# Drawing Change Notice

CHANGE DOCUMENT NO.  
24590-LAW-P1N-P01T-00057

JOB NO. 24590	TITLE FOR CHANGE NOTICE REVISION TO LAW UPS BATTERY ROOM LAYOUT
------------------	--

DESIGN DOCUMENT NUMBER	REV	DESIGN DOCUMENT NUMBER	REV
24590-LAW-P1-P01T-00004	4		
24590-LAW-P1-P01T-00005	3

**CURRENT LAYOUT**  
**24590-LAW-P1-P01T-00005 REV. 3**  
**24590-LAW-P1N-P01T-00057**

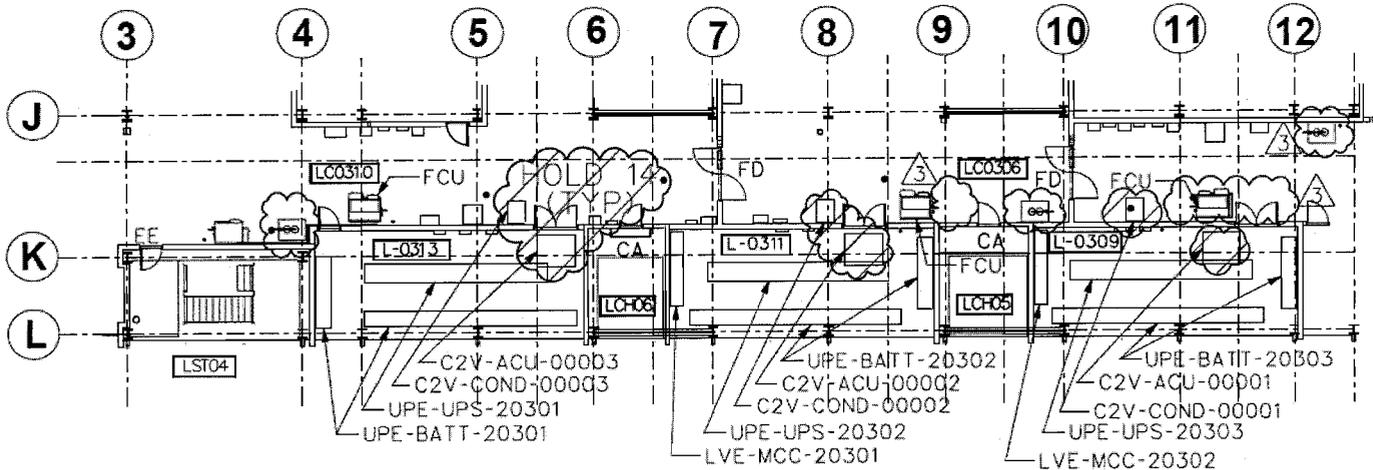
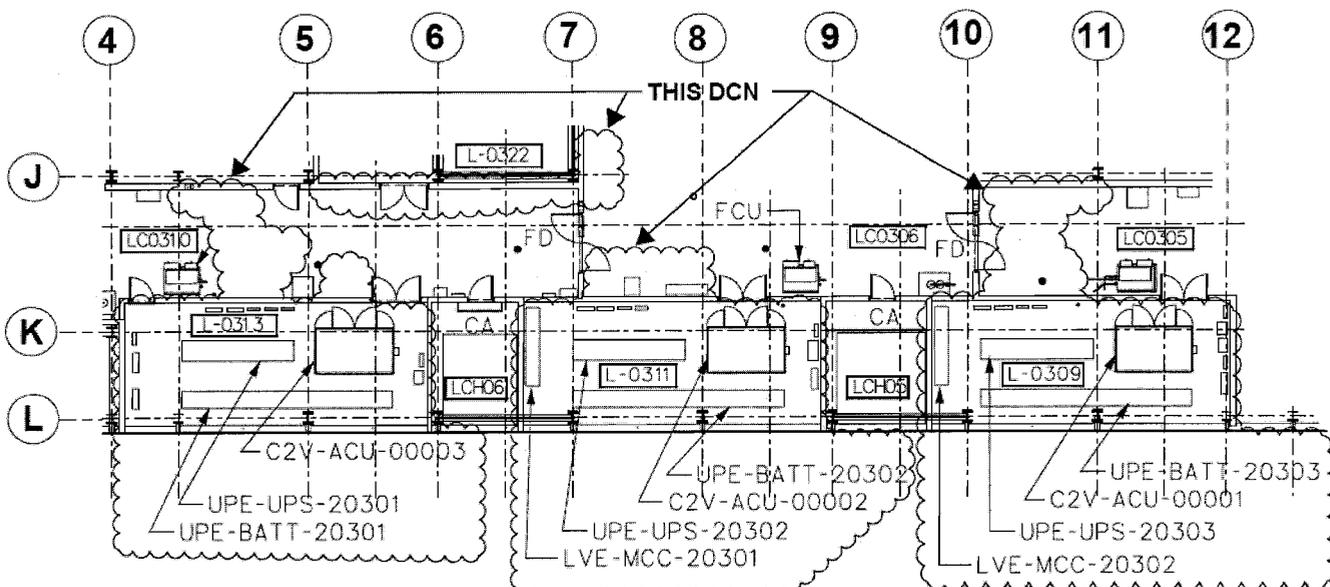
**L-0313 (SEE PAGE 4)**

- REMOVED HOLD CLOUD 14 FOR C2V-ACU-00003
- REVISED SIZE OF C2V-ACU-00003
- REVISED SIZES OF UPE-BATT-20301 AND UPE-UPS-20301
- RELOCATED UPE-XFMR-20350, UPE-PNL-20350, LVP-PNL-20322, LVP-XFMR-20322 FROM CORRIDOR LC0310 (NOTE 1)
- ADDED SS HVAC CONTROL PANELS C2V-PNL-00116 AND C3V-PNL-00015 (NOTE 1)
- DELETED SECTION OF UPE-BATT-20301 AT COLUMN 4
- ADDED BATTERY RACK DISCONNECT SWITCH UPE-SW-20301 (NOTE 1)

**LC0310 (SEE PAGE 4)**

- REMOVED HOLD CLOUD 14 FOR C2V-COND-00003
- RELOCATED C2V-COND-00003 TO EXTERIOR PLATFORM. (PAGE 5)
- DELETED LVE-ENCL-000023 TO ALIGN WITH C&I DESIGN DOCUMENTS (NOTE 1)
- RELOCATED UPE-XFMR-20350, UPE-PNL-20350, LVP-PNL-20322, LVP-XFMR-20322 TO L-0313 (NOTE 1)

### L-0311 (SEE PAGE 4)

1. REMOVED HOLD CLOUD 14 FOR C2V-ACU-00002
2. REVISED SIZE OF C2V-ACU-00002
3. REVISED SIZES OF UPE-BATT-20302 AND UPE-UPS-20302
4. RELOCATED UPE-XFMR-20351, UPE-PNL-20351 FROM CORRIDOR LC0306 (NOTE 1)
5. ADDED SS HVAC CONTROL PANELS C2V-PNL-00115 AND C3V-PNL-00014 (NOTE 1)
6. DELETED SECTION OF UPE-BATT-20302 AT COLUMN 9
7. ADDED BATTERY RACK DISCONNECT SWITCH UPE-SW-20302 (NOTE 1)

### LC0306 (SEE PAGE 4)

1. REMOVED HOLD CLOUD 14 FOR C2V-COND-00002
2. RELOCATED C2V-COND-00002 TO EXTERIOR PLATFORM. (PAGE 5)
3. RELOCATED UPE-XFMR-20351, UPE-PNL-20351 TO L-0311 (NOTE 1)
4. RELOCATED EMJ-ENCL-00008 TO COLUMN K13. (NOT SHOWN ON THIS DCN)
5. ADDED FPW-CAB-00001 (NOTE 1)
6. ADDED LVE-ENCL-00002 (NOTE 1)

### L-0309 (SEE PAGE 4)

1. REMOVED HOLD CLOUD 14 FOR C2V-ACU-00001
2. REVISED SIZE OF C2V-ACU-00001
3. REVISED SIZES OF UPE-BATT-20303 AND UPE-UPS-20303
4. RELOCATED LVE-PNL-20323, LVE-XFMR-20323, LTE-PNL-20301, LTE-XFME-20301 FROM CORRIDOR LC0310 (NOTE 1)
5. ADDED SS HVAC CONTROL PANELS C2V-PNL-00114 AND C3V-PNL-00013 (NOTE 1)
6. DELETED SECTION OF UPE-BATT-20303 AT COLUMN 12
7. ADDED BATTERY RACK DISCONNECT SWITCH UPE-SW-20303 (NOTE 1)

### LC0305 (SEE PAGE 4)

1. REMOVED HOLD CLOUD 14 FOR C2V-COND-00001
2. RELOCATED C2V-COND-00001 TO EXTERIOR PLATFORM (PAGE 5)
3. RELOCATED LTE-PNL-20301, LTE-XFMR-20301, LVE-PNL-20323, LVE-XFME-20323, LVE-PNL-20324, LVE-XFMR-20324 TO L-0309 (NOTE 1)

**CURRENT LAYOUT**  
**24590-LAW-P1-P01T-00004 REV. 4**  
**24590-LAW-P1N-P01T-00057**

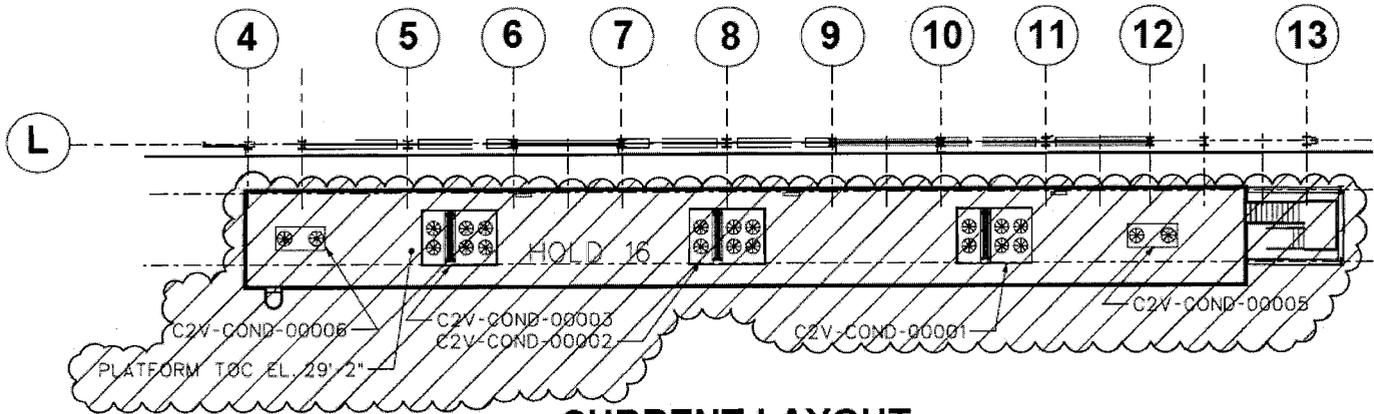
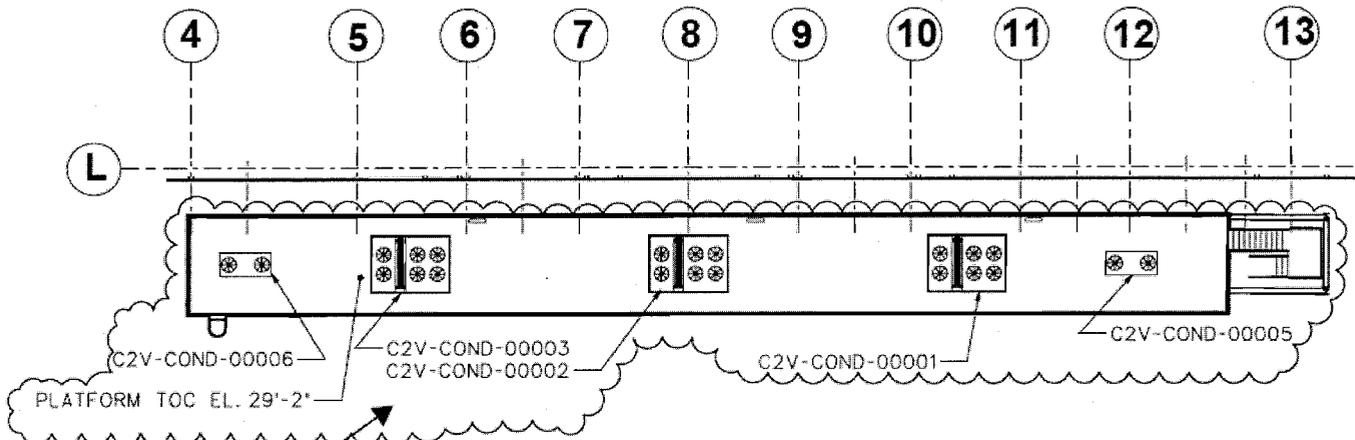
### EXTERIOR CONDENSER PLATFORM (SEE PAGE 5)

1. REMOVED HOLD CLOUD 16

**CURRENT LAYOUT L-0304C/D/E**  
**24590-LAW-P1-P01T-00005 REV. 3**  
**24590-LAW-P1N-P01T-00057**

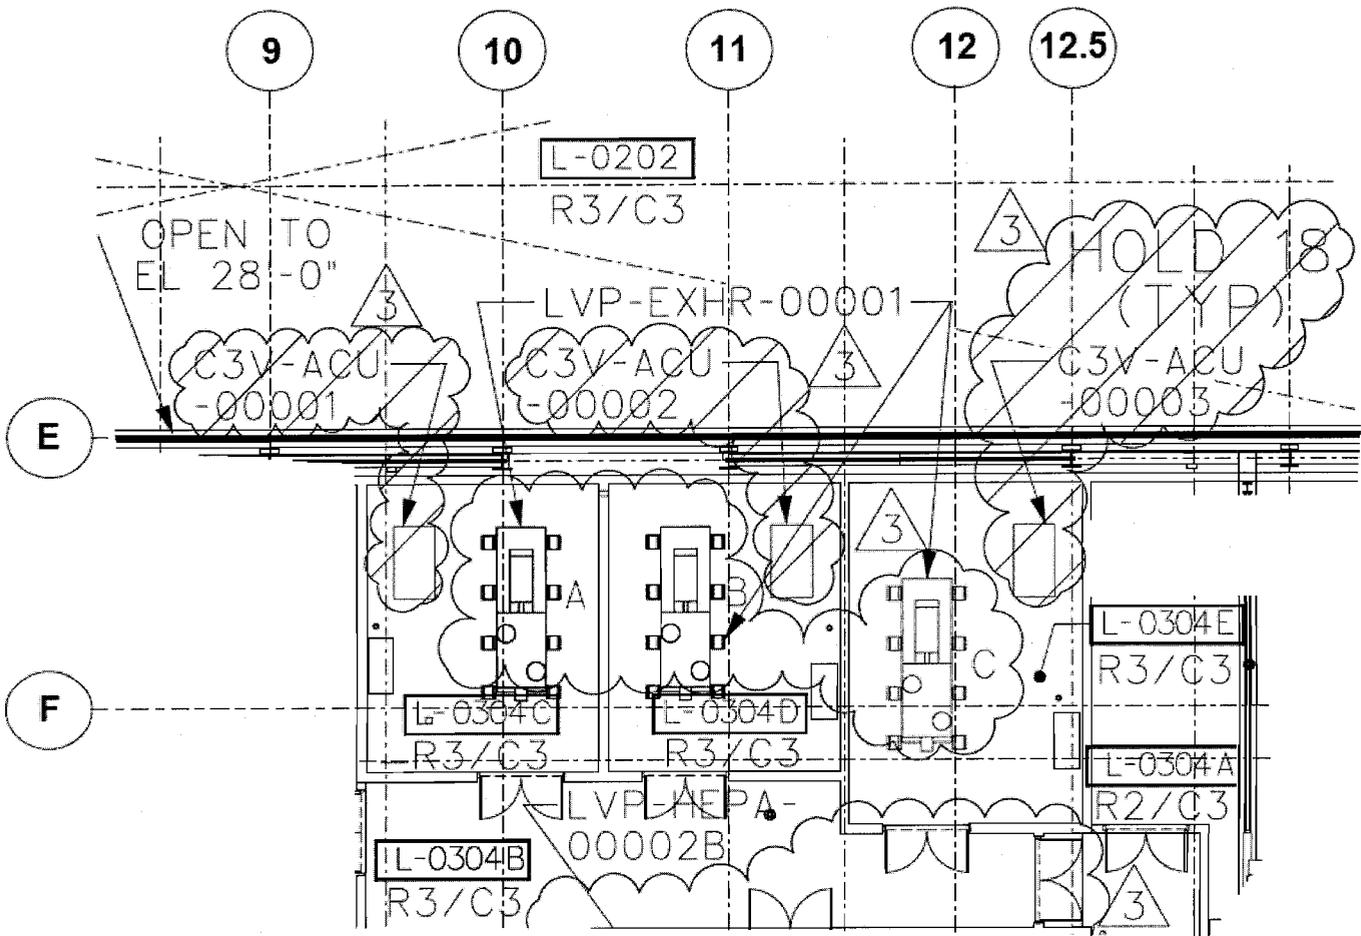
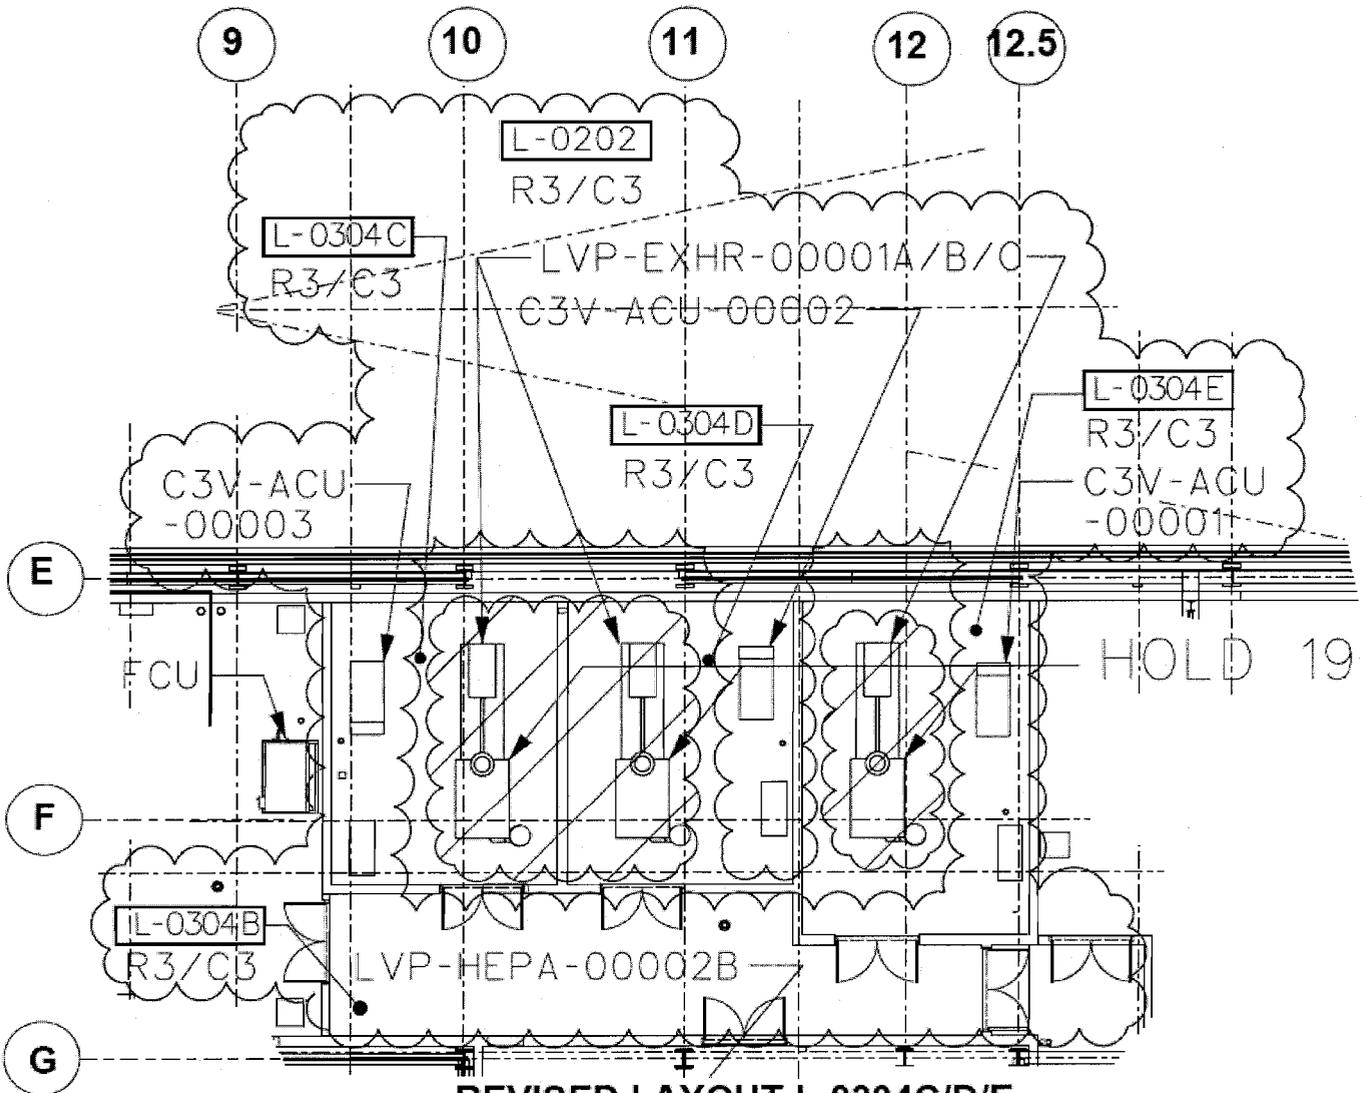
### **ROOM L-0304C (SEE PAGES 6 AND 7)**

1. REMOVED HOLD 18, REVISED AND RELOCATED C3V-ACU-00001
2. RELOCATED LVP-ASD-00001A
3. REVISED PRELIMINARY SIZE OF LVP-EXHR-00001A AND ADDED HOLD 19 PENDING RECEIPT OF NEW CODE 2 SUBMITTALS
4. CORRECTED LABEL FROM C3V-ACU-00001 TO C3V-ACU-00003

### **ROOM L-0304D (SEE PAGES 6 AND 7)**

1. REMOVED HOLD 18, REVISED AND RELOCATED C3V-ACU-00002
2. RELOCATED LVP-ASD-00001B
3. REVISED PRELIMINARY SIZE OF LVP-EXHR-00001B AND ADDED HOLD 19 PENDING RECEIPT OF NEW CODE 2 SUBMITTALS

### **ROOM L-0304E (SEE PAGES 6 AND 7)**

1. REMOVED HOLD 18, REVISED AND RELOCATED C3V-ACU-00003
2. RELOCATED LVP-ASD-00001C
3. REVISED PRELIMINARY SIZE OF LVP-EXHR-00001C AND ADDED HOLD 19 PENDING RECEIPT OF NEW CODE 2 SUBMITTALS
4. CORRECTED LABEL FROM C3V-ACU-00003 TO C3V-ACU-00001
